MetroWest+

Portishead Branch Line (MetroWest Phase 1)

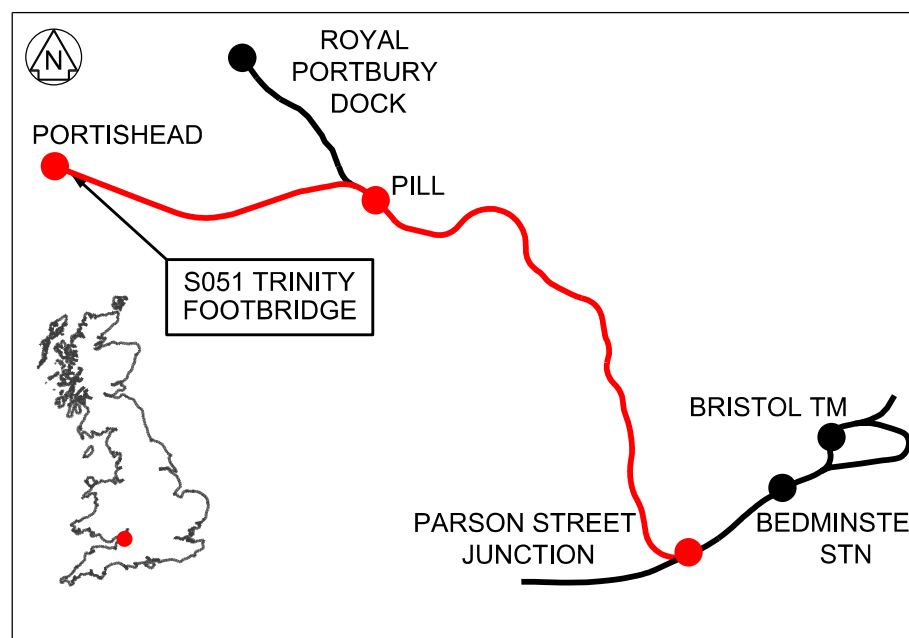
Rev	Date	Description of Revisions	Drawn	Chkd	Appr
A01	04/12/15	ISSUED FOR FORM F001			
A02	30/01/19	ISSUED FOR FORM F001 ADDENDUM			
Status			S3

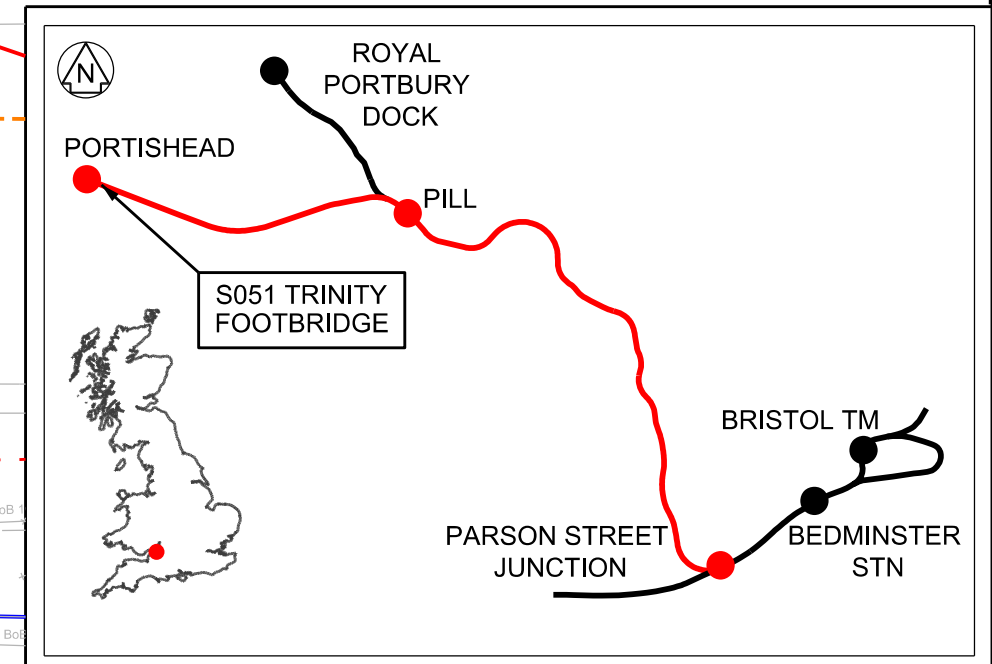
Rev	Date	Description of Revisions	Drawn	Chkd	Appr
A01	04/12/15	ISSUED FOR FORM F001	MF	JA	CW
A02	30/01/19	ISSUED FOR FORM F001 ADDENDUM	LS	RS	CW
